ALERT SERVICE BULLETIN

SUBJECT: **REVISION "B" TO ALERT SERVICE BULLETIN 205-00-76: (MAIN ROTOR MAST 204-011-450-007/-105 INSPECTION AND RETIREMENT INDEX NUMBER RIN REDUCTION)**

NO. 205-00-76

SUBJECT: MAIN ROTOR MAST, P/N 204-011-450-007/ -105/ -113/ -119, INSPECTION AND RETIREMENT INDEX NUMBER (RIN) LIFE REDUCTION

Figure 1
Main rotor mast 204-011-450-007/-105

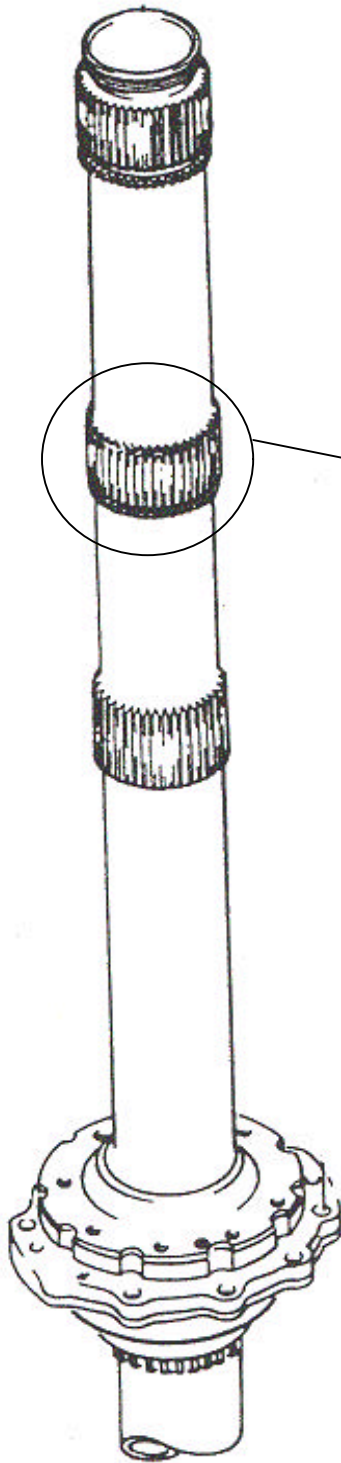
1. Inspect the mast snap ring upper and lower grooves (entire circumference) for a minimum radius of 0.020 (figure 2, and figure 3 view A-A). Any mast that has indications of a radius less than 0.020 shall apply a 165,000 RIN penalty to the mast.

- At 100X minimum magnification
Minimum radius of 0.020 in the
upper and lower snap ring groove,
entire circumference
- At 200X minimum magnification
Burr in the snap ring groove/spline
intersection, all places

Figure 2
Snap ring groove / spline intersection

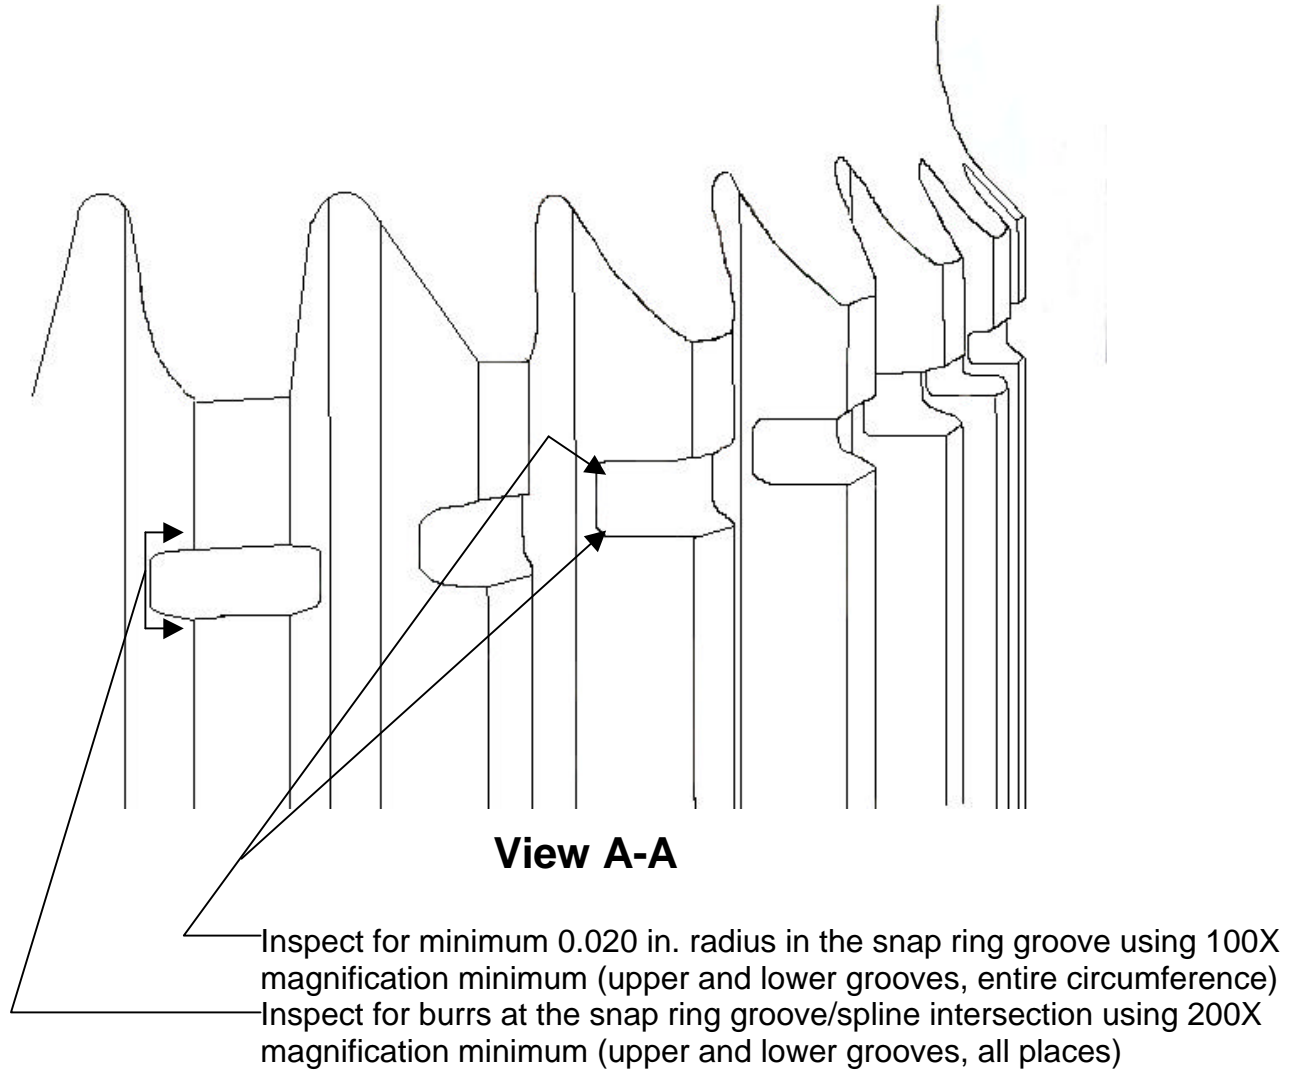
2. Inspect the mast snap ring upper and lower grooves for indications of burrs at all intersections with splines (see figure 3 view A-A, and figure 4). Any mast that has indications of a burr shall apply a 95,000 RIN penalty to the mast. Burr removal should not be accomplished.
3. Masts not exhibiting insufficient radius or burrs in the snap ring groove may continue in service until reaching the revised retirement of 265,000 RINs/15,000 hours.
4. Annotate Historical Service Records showing compliance with this bulletin.

FIGURE 3

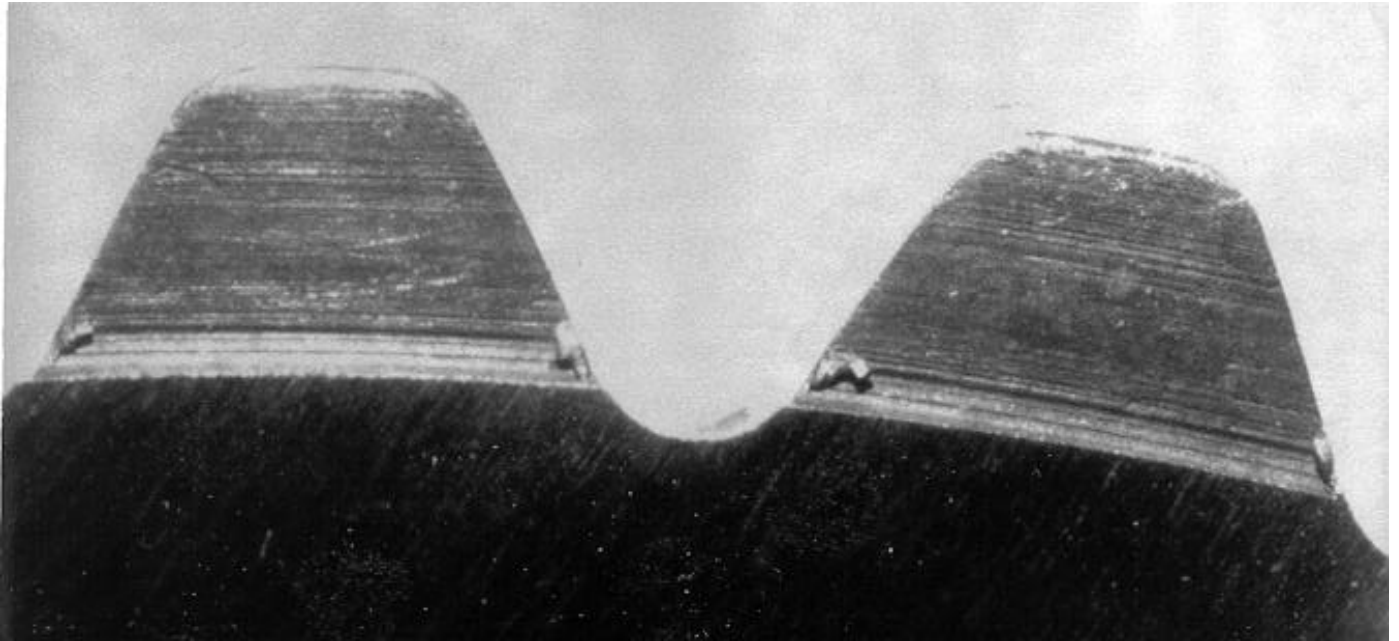
Typical burrs at snap ring groove/spline intersection
Burrs are to be inspected at 200X minimum magnification
